SUBJECT: Service Bulletin No. 116

SERVICE BULLETIN 116

SUBJECT Superpressure Blower**APPLICABILITY** Raven Burner Models HP2C-101 to 164**PROBLEM** Change in dimension of fan hub affects position of upper face fan hub to motor shaft.**CORRECTIVE ACTION**

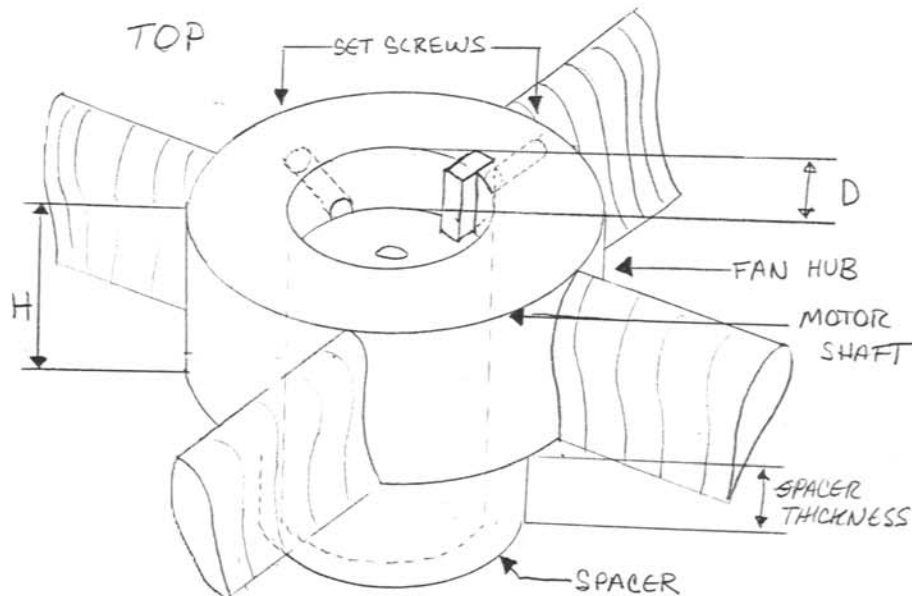
The supplier of the fan for this system has modified the fan hub dimensions slightly without any notification. The dimension change is pictured on the enclosed service bulletin as dimension "H" which was originally 1.45 inches. This change makes the thickness of the spacer very critical.

With the original 1.45 inch fan hub, the original spacer (.55 inch) brought the upper face of the fan hub flush or nearly flush with the motor shaft. The more recent fan hub with the .55 inch spacer brings the upper face as much as 3/8 inch above the motor shaft end. Consequently, it is possible that the hub set screws will only contact partially with the motor shaft end key. This means the fan could come loose over a period of time.

1. Remove blower assembly from burner.
2. Remove 10 cap screws which retain upper screen on top side of blower. Remove screen.
3. Using above illustration as a guide, measure distance D , shaft depth. If this distance is greater than $3/16$ inch, proceed to step 5.
4. If distance D is $3/16$ inch or less, the fan hub distance H is nominally 1.45 inches which is acceptable. Fill out the blower card and check the box marked "Spacer not required." Replace the blower screen and snug the cap screws. Please return the card to Raven.
5. If distance D is greater than $3/16$ inch, fill out the blower card and check the box marked "Spacer required." If rapid service is needed, call Raven and request a new spacer. It

6. Remove fan and hub. This may be done first by loosening two set screws several turns and then using a puller, such as a gear puller, steering wheel puller or another type.
7. Remove the old spacer and replace with new spacer. Replace fan, hub and key. Tap hub gently with a hammer to seat the assembly onto the spacer. (Check to be sure the fan blades do not hit the motor mount bolt-heads during rotation.) Tap key gently into place so it is flush with the face of the hub. Tighten set screws and replace upper screen and cap screws.
8. Please return the "Work Performed" card to Raven with the appropriate information.
